P94-055 Entitlements to allow back out parking and a waiver of three parking spaces for a multi-family residence in the Alhambra Corridor's Multi-Family (R-4) zone

- REQUEST: A. Special Permit to allow the construction of a multi-family residence in the Multi-Family (R-4) zone;
- B. Special Permit to waive three parking spaces; and,
- C. Variance to allow back out parking on a 40' X 80' (3,200 square foot) parcel in the Multi-Family Residential (R-4) zone.

LOCATION: 2604 H Street
007-0035-004
Central City Community Plan Area, Council District #3

FRONT ELEVATION
SCALE 1/4" = 1'-0"

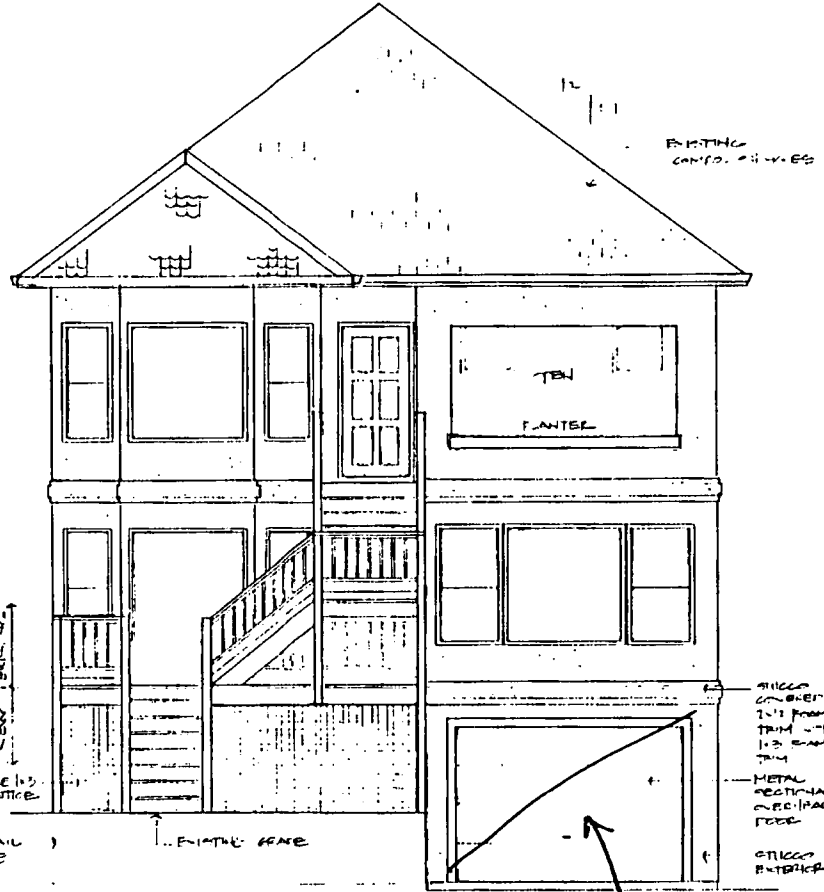
Design Review staff is recommending that the aluminum windows on the ground floor be replaced with windows that will better reflect the character of the building and neighborhood.

EXHIBIT 1

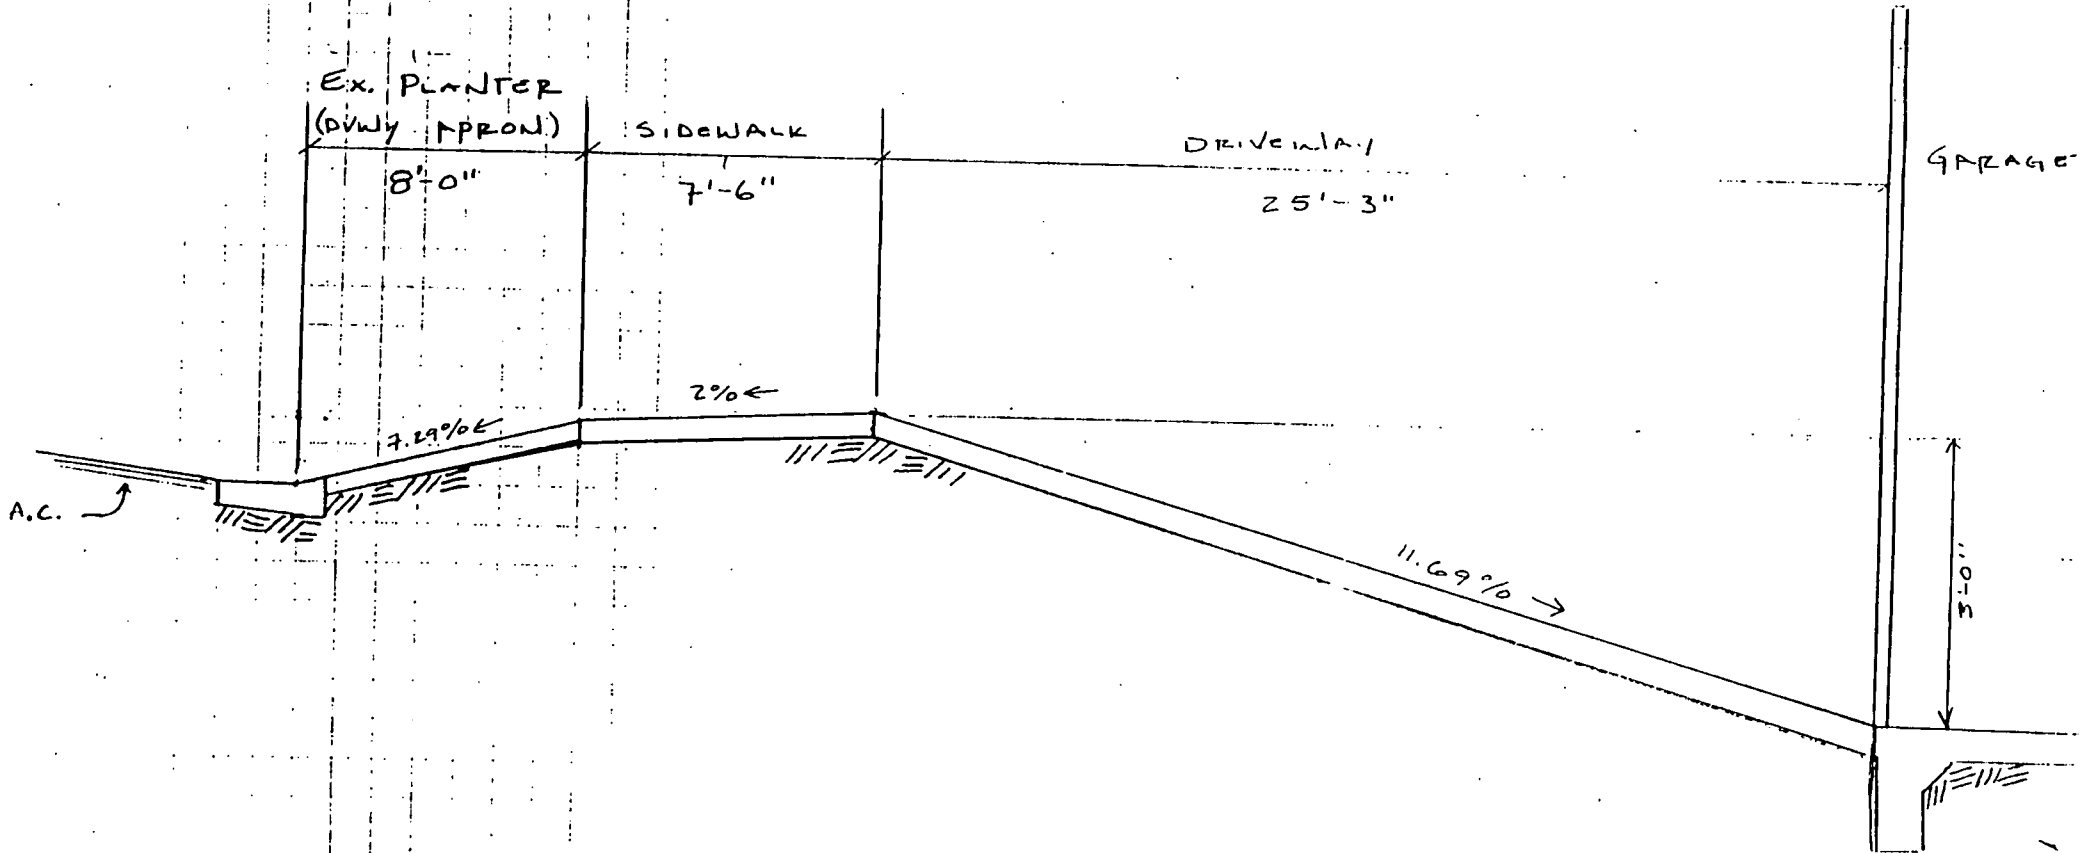
The lengths of the proposed driveway, sidewalk and planter (driveway apron) were measured at the site. The attached Exhibit 1 shows a profile of the proposed driveway. The driveway apron slope was estimated assuming an 8" vertical curb, which is consistent with current City standards. The actual curb may actually be taller, which would increase the apron's slope. The sidewalk was assumed to have a standard 2% cross slope. The driveway slope was estimated based on the applicant's information that the driveway is 3'-0" below the back of sidewalk.

The attached exhibit indicates the grade difference between the driveway and the sidewalk is 13.69% and the grade difference between the driveway and the apron is 18.98%. (Caltrans recommends a maximum grade difference of 13% at driveways along public streets). Kim Yee and myself concur that the driveway design will result in vehicles bottoming-out between the driveway apron and the proposed driveway. Therefore, the driveway must be redesigned and/or eliminated as we discussed at our meeting.

The City Code requires driveways to have a maximum 4% slope for a distance of 20 feet from the street right-of-way. Any driveway that does not meet this requirement will require a City Council variance. Since the proposed driveway is not acceptable (as stated above) this office cannot support a variance for the driveway as proposed.
